Morningside and Bruntsfield, Edinburgh

Temporary Pedestrian and Cycle Infrastructure

Road Safety Audit Stage 3

Overseeing Organisation Reference: RSA/20/033
AECOM Reference: RSA/284/S3-A

Problem: 4.1.1

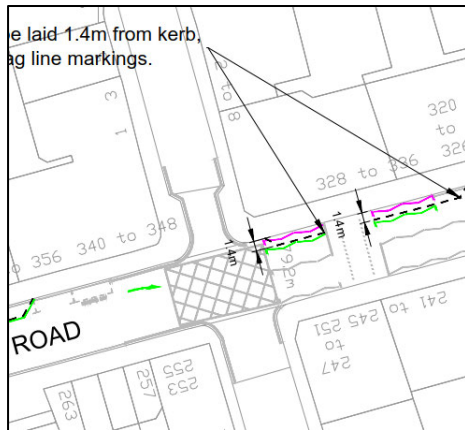
Summary: Risk of left turning vehicles colliding with temporary kerb units and losing control, due to proximity of kerb units to side road junction and lack of road markings / signage

As shown in the image and photograph above, a temporary pedestrian area is provided on Morningside Road immediately north of Millar Crescent. The Audit Team have concerns that the driver / rider of a vehicle turning left from Millar Crescent may be unaware of the build out and may have insufficient time to react. This could lead to them colliding with the temporary kerb units and losing control of their vehicle.

It is recommended that the temporary footway area that is demarcated by the temporary kerb units is offset further from the side road junction. It is also recommended that appropriate measures are provided to alert the drivers / riders of left turning vehicles to the change in carriageway alignment on the carriageway, such as road markings and / or traffic signage.

Problem: 4.3.1

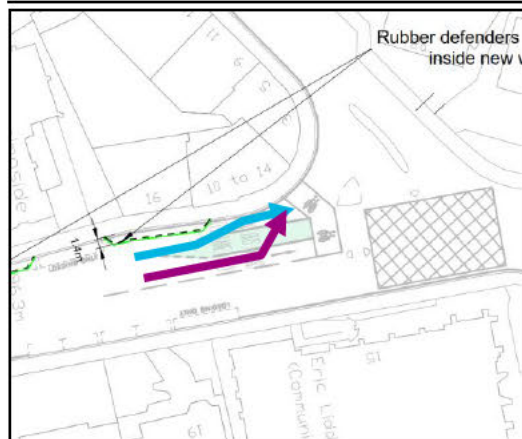
Summary: Risk of late lane changes due to unclear junction arrangement, leading to side-swipe collisions.

The scheme includes a build out on the west side of Morningside Road, immediately south of its junction with Colinton Road. This build out shortens the left turn lane, forcing vehicles to enter or cross the bus lane in order to access it.

There is a risk that vehicles may make late lane changes when attempting to access the left turn lane, due to the unclear arrangement. This could lead to side-swipe collisions occurring.

It is recommended that the road marking arrangement at the junction is altered to clarify how motorised road users should access the left turn lane.

Problem: 4.5.3

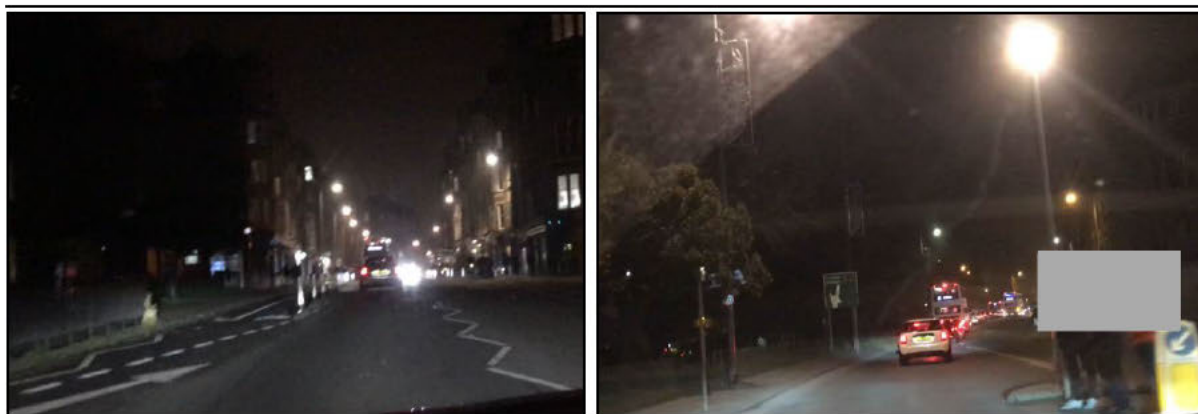
Summary: Risk of vehicles colliding with crossing pedestrians, resulting in the pedestrians sustaining personal injuries, or vehicles colliding with temporary kerb units and losing control, due to insufficient illumination.

During the site investigation that was undertaken during the hours of darkness it was observed that two lighting columns were not functioning: one on Bruntsfield Place opposite Leamington Terrace and the other on Morningside Road opposite Maxwell Street. When lighting columns are not functioning, dark spots can form on the carriageway and footways. There is a risk that this could lead to vehicles colliding with crossing pedestrians, resulting in the pedestrians sustaining personal injuries, or vehicles colliding with temporary kerb units and losing control.

It is recommended that the lighting columns that are not functioning are appropriately repaired.
